# **SAND HILL WIND PROJECT FINAL ENVIRONMENTAL IMPACT REPORT**

**State Clearinghouse #2013032016  
March 2014**

# Comments

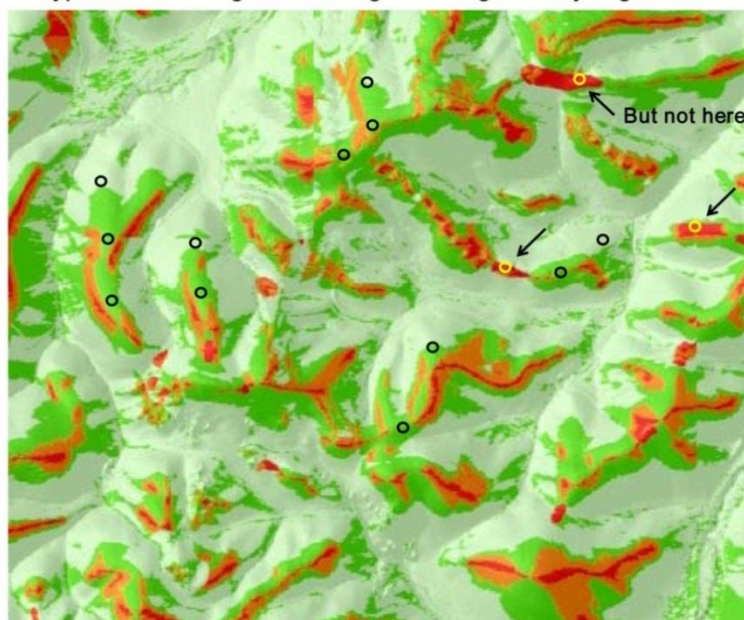
O2-17

Hypothetical siting relative to golden eagle Fuzzy Logic model

**Table 4-3. Comparison of Avian and Bat Impacts under the Alternatives to the Proposed Project**

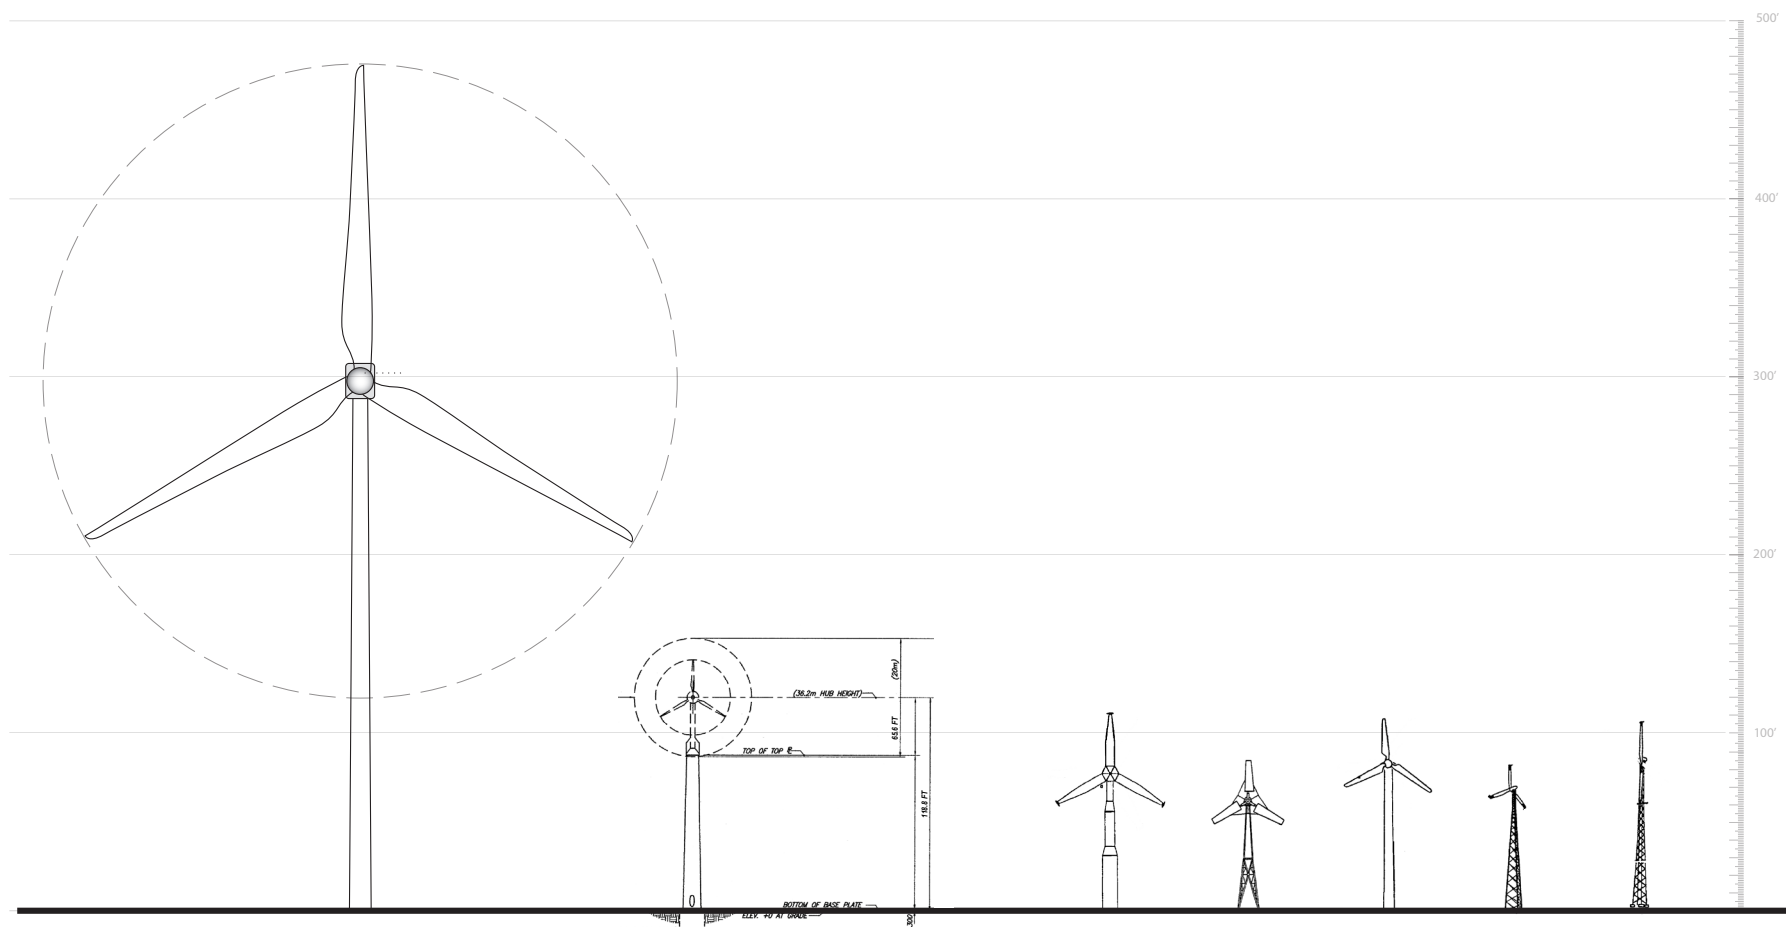
**Page 4-34, Table 4-3 has been added to clarify impacts between alternatives to focal species and bats.**

Figure 3.4-2  
Special-Status Species Occurrences and Suitable Breeding Habitat  
for California Red-Legged Frog and California Tiger Salamander

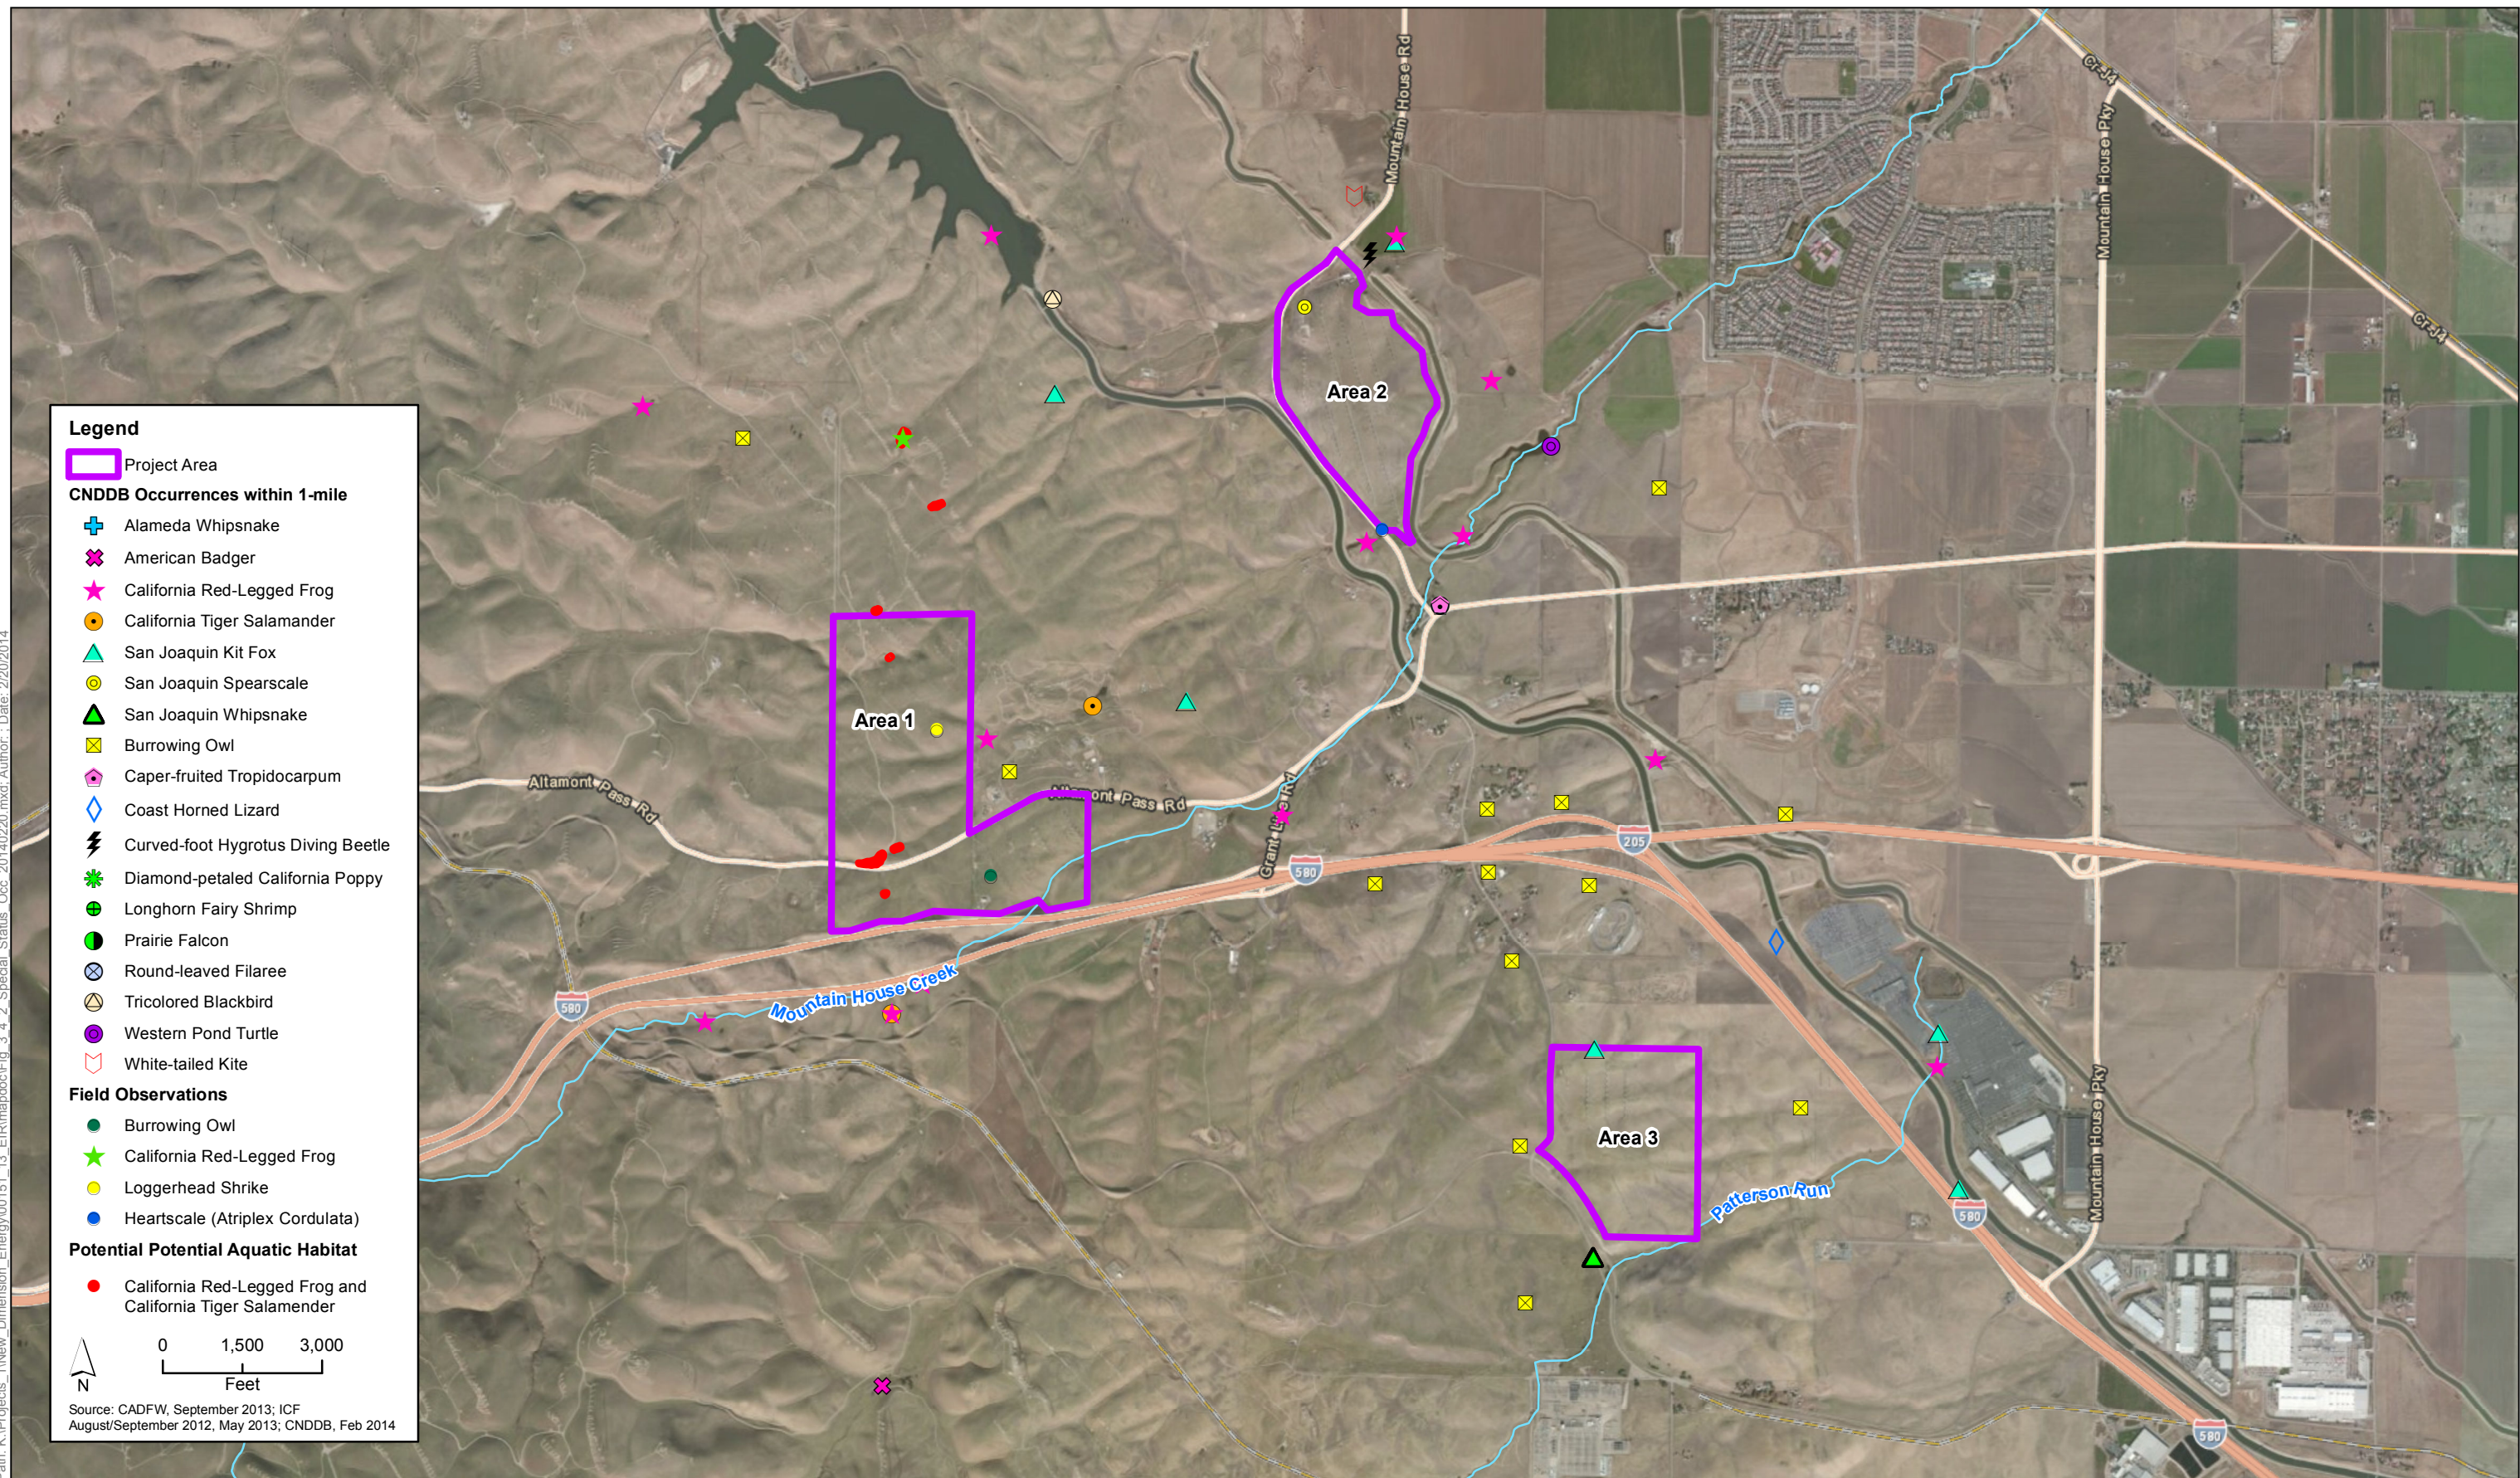
**Following page 3.4-8, Figure 3.4-1 Biological Communities has been revised. Perennial wetlands were inadvertently omitted (see revised figure at the end of this chapter).**
